Product Change Notice (PCN)

PCN Number: PCN-0450904R-01

SJ1-42534-SMT-TR, SJ1-42535TS-SMT-TR, SJ1-42536-SMT-TR

Reason(s) for Change: *Manufacturing process improvements*

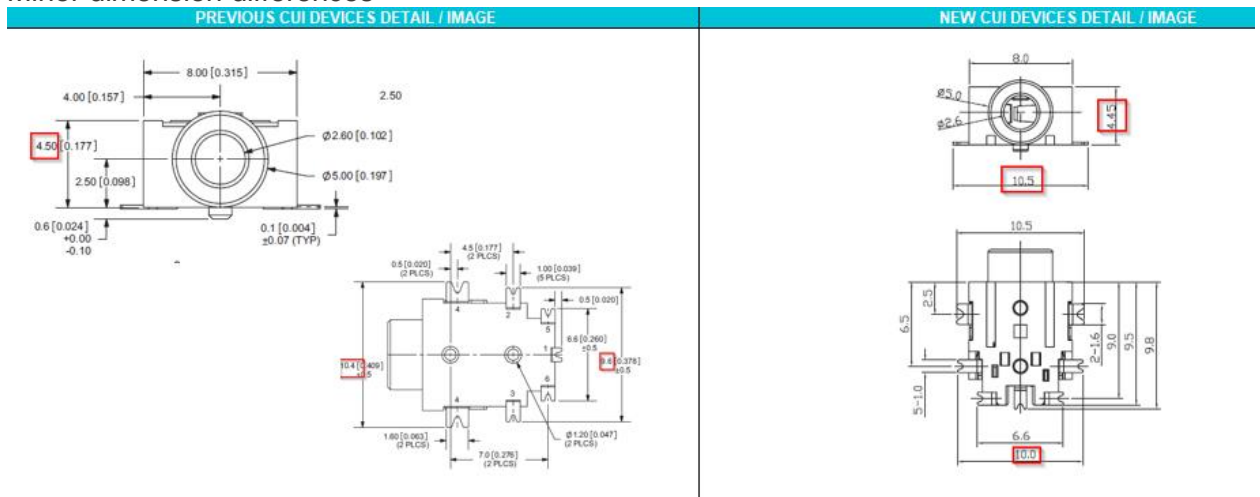
1. Minor dimension differences

2. PCB pad size differs

PREVIOUS CUI DEVICES DETAIL / IMAGE	NEW CUI DEVICES DETAIL / IMAGE
<p>Recommended PCB Layout Top View</p>	<p>Recommended PCB Layout Top View</p>

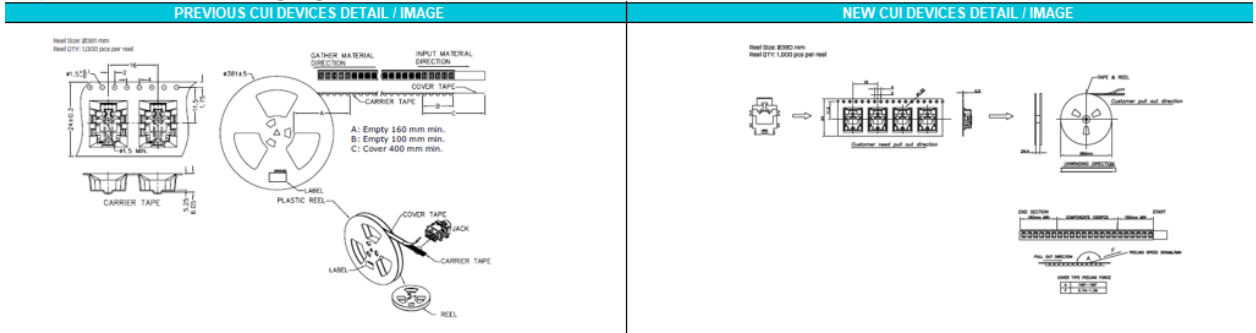
4. Reflow Soldering Difference

PREVIOUS CUI DEVICES DETAIL / IMAGE	NEW CUI DEVICES DETAIL / IMAGE																																										
<p>SOLDERABILITY</p> <table border="1"> <thead> <tr> <th>parameter</th> <th>conditions/description</th> <th>min</th> <th>typ</th> <th>max</th> <th>units</th> </tr> </thead> <tbody> <tr> <td>refl storage</td> <td>at relative humidity <80%</td> <td></td> <td></td> <td>40</td> <td>°C</td> </tr> <tr> <td>reflow soldering¹</td> <td>see reflow profile</td> <td>255</td> <td>260</td> <td>265</td> <td>°C</td> </tr> <tr> <td>drying conditions²</td> <td>parts on reel: bake at 40°C ±5°C for 72 hours parts removed from reel: bake at 40°C ±5°C for 10 hours</td> <td></td> <td></td> <td></td> <td></td> </tr> </tbody> </table> <p>Notes: 3. Must reflow solder within 72 hours from opening vacuum packaging at a temperature <30°C & relative humidity <60%. 4. When exceeding floor life by >72 hours.</p>	parameter	conditions/description	min	typ	max	units	refl storage	at relative humidity <80%			40	°C	reflow soldering ¹	see reflow profile	255	260	265	°C	drying conditions ²	parts on reel: bake at 40°C ±5°C for 72 hours parts removed from reel: bake at 40°C ±5°C for 10 hours					<p>SOLDERABILITY</p> <table border="1"> <thead> <tr> <th>parameter</th> <th>conditions/description</th> <th>min</th> <th>typ</th> <th>max</th> <th>units</th> </tr> </thead> <tbody> <tr> <td>refl storage</td> <td>5-25°C, 60-75% humidity</td> <td></td> <td></td> <td>40</td> <td>°C</td> </tr> <tr> <td>reflow soldering</td> <td>see reflow profile</td> <td>255</td> <td>260</td> <td></td> <td>°C</td> </tr> </tbody> </table> <p>Note: 1. CUI Devices recommends usage of the product within 24 hours after 100 is opened. After 24 hours, CUI Devices recommends drying the parts prior to use.</p>	parameter	conditions/description	min	typ	max	units	refl storage	5-25°C, 60-75% humidity			40	°C	reflow soldering	see reflow profile	255	260		°C
